**APPENDIX D**  
**VALUE ENGINEERING STUDY**

**FINAL REPORT**  
**VALUE ENGINEERING STUDY**

**CDOT – Region 5**  
**US 550 Environmental Assessment**

**December 2003**

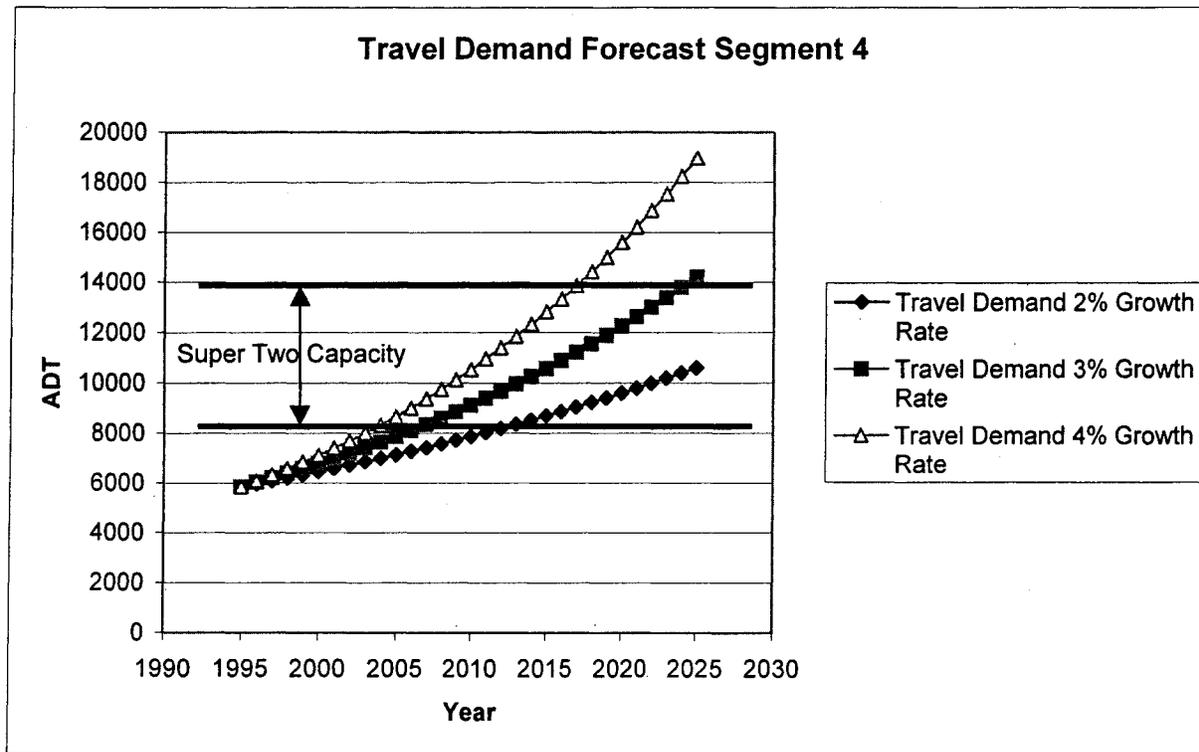
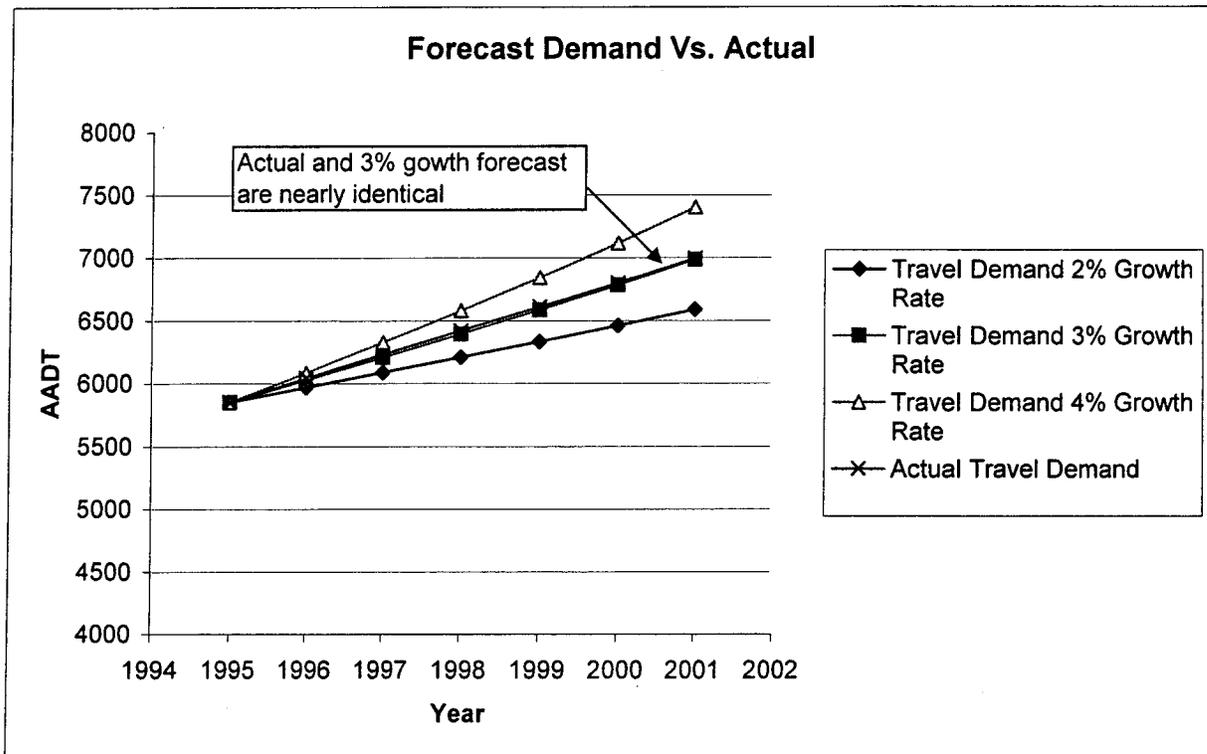
A study published in Transportation Research Record (TRR) 1303, "Warrants for Passing Lanes", shows that Passing Lanes on rural two-lane highways have a favorable benefit/cost ratio at AADTs of 6500 and greater. Based on the above, a principal arterial two-lane rural highway or selected high volume minor arterial routes could qualify to be considered for a Super Two design once it is scheduled for major upgrading or reconstruction, and the projected volume is 6000 ADT in the year after the segment is open to traffic. Construction of Super Twos, or selective use of some features of the Super Twos, may also be necessitated by high seasonal peaks, heavy commercial vehicle volumes and other unique traffic and terrain situations. Currently the volumes along US 550 are at or near these thresholds; 5850 ADT in 1995 and 6995 ADT in 2001.

The projected 2025 forecasted volumes for this corridor range from 12,960 ADT (south) to 18,100 ADT (north). These volumes are peak seasonal and apparently only occur two months of the year. A Super Two can typically handle between 12,000 – 15,000 ADT. Volumes above that will compromise the capacity and LOS. In addition, the Super Two concept is typically implemented on highways with a 70 mph design speed, and a corresponding 60 mph posted speed. The 550 corridor is currently classified and planned to provide for a 70 mph design speed with 60 to 70 mph posting.

As illustrated in this graph, the 2025 projections differ significantly based on the travel demand growth rate assumption.

The Super Two concept may be applicable for this corridor assuming a 2-3% growth rate, and may be applicable assuming a 4% growth rate though about 2018. At this time (2018) the Super Two highway may be expanded to a four lane divided section with minimal "Throwaway".

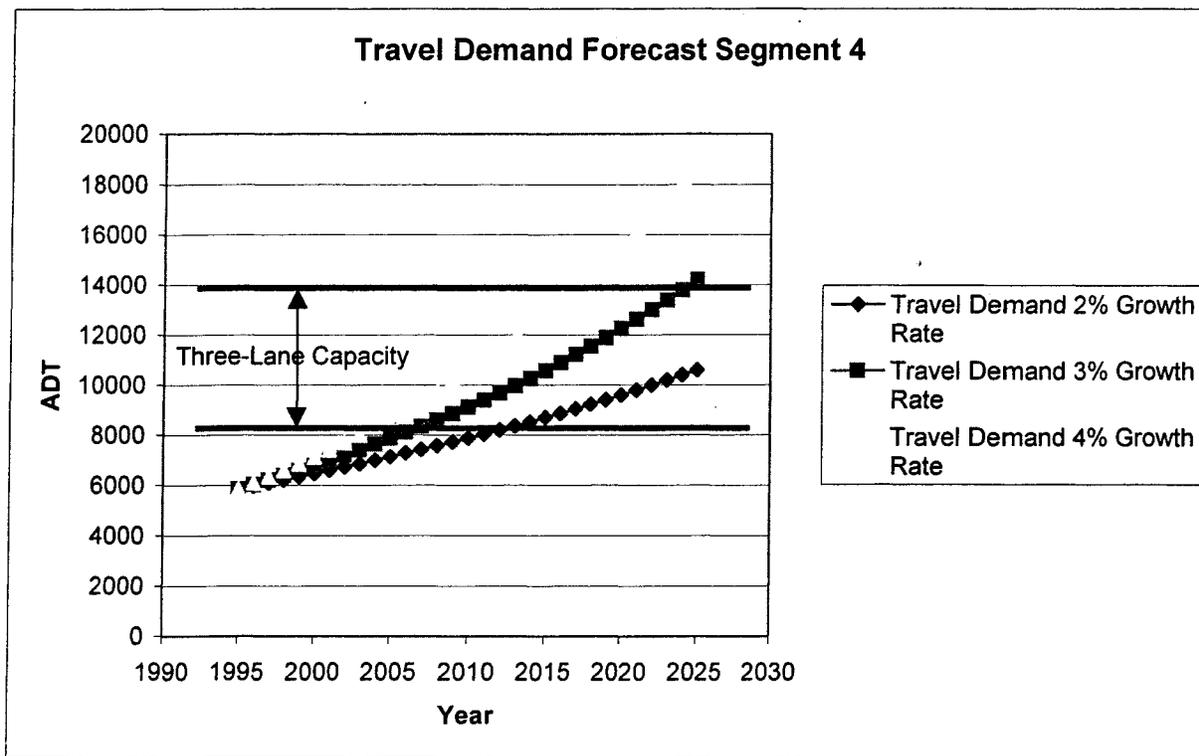
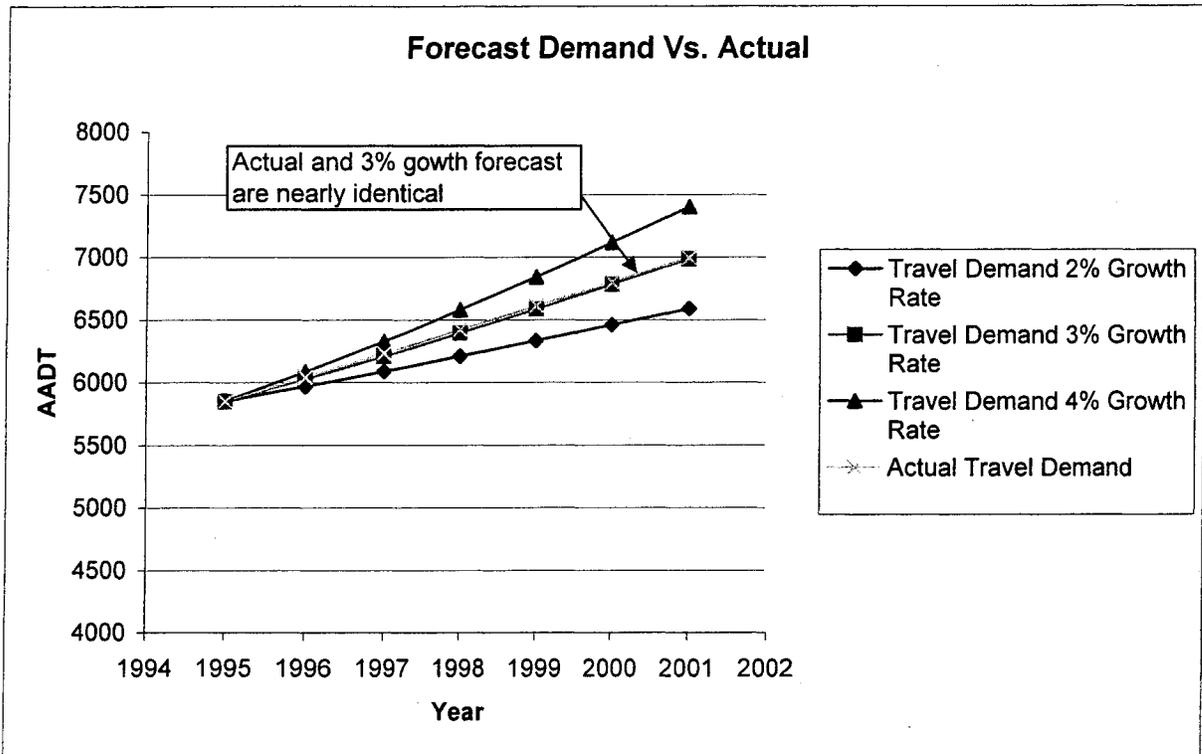
In order to optimize operations along the length of the corridor, passing lanes should be between 1 to 3 miles in length and alternate to make best use of left turn locations and avoid conflict with access points. It is not recommended to have traffic slowing down to

turn left from the passing lane; therefore, passing lanes should not be located where this condition exists.

As illustrated in this graph, the 2025 projections differ significantly based on the growth rate assumption.

The three-lane concept may be applicable for this corridor assuming a 2-3% annual growth rate, and may only be applicable assuming a 4% growth rate though about 2018.

06-011

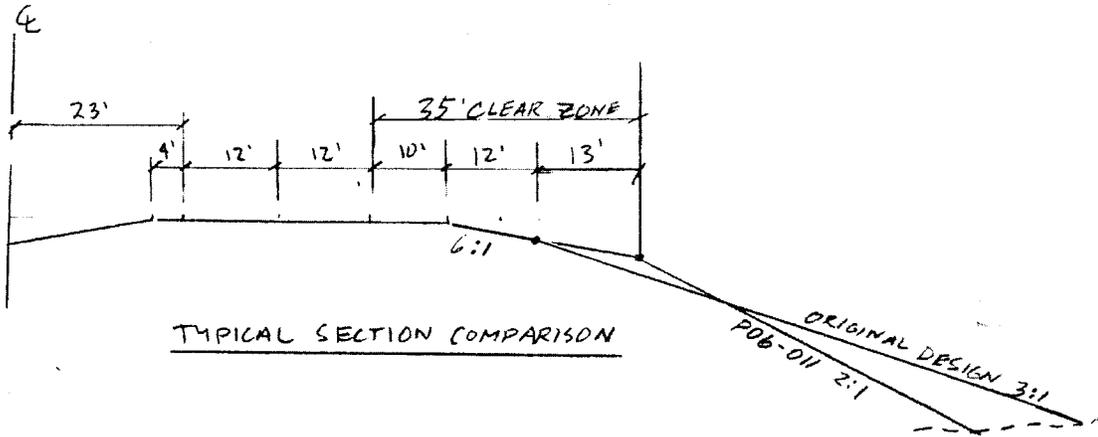
In addition to the earthwork and right of way cost savings, this design may also provide safety advantages, as a result of the added clear zone at the top of the fill. Though the 3:1 side slopes of the original design are considered to traversable by a vehicle, they actually present a safety hazard due to overturning potential for high gravity centered vehicles such a SUV's.

See attached calculations

01-008

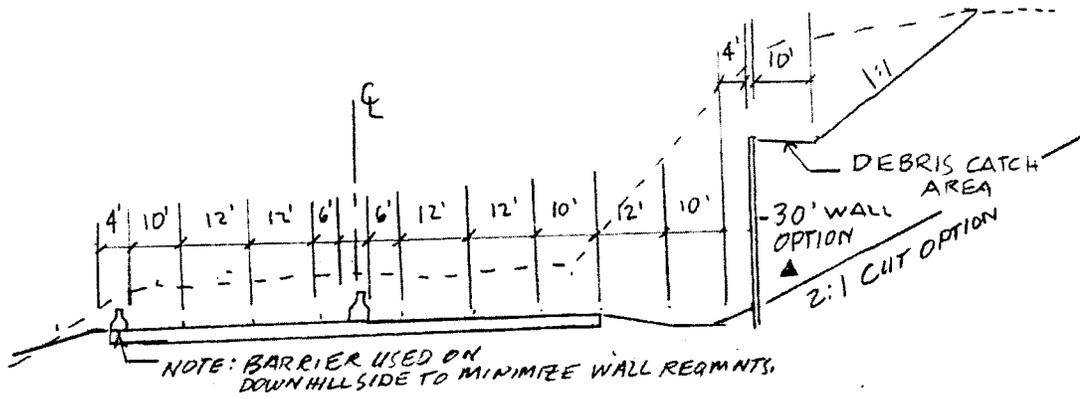
The horizontal alignment is similar to Alternative 2A of the original design, but with slightly flatter horizontal curvature (R=2050', versus 1910'), and lateral shifts of the control line location of up to 100', to provide a better balance of earthwork. The vertical alignment is an improvement relative to Alternative 2A (5% grade versus 6% grade), and equivalent to the vertical alignment of Alternative 2B.

The alignment provide a good balance of earthwork for Section 2, by cutting into Bondad Hill on the west side of the roadway, rather than using an uphill retaining wall.

See attached calculations and drawings.
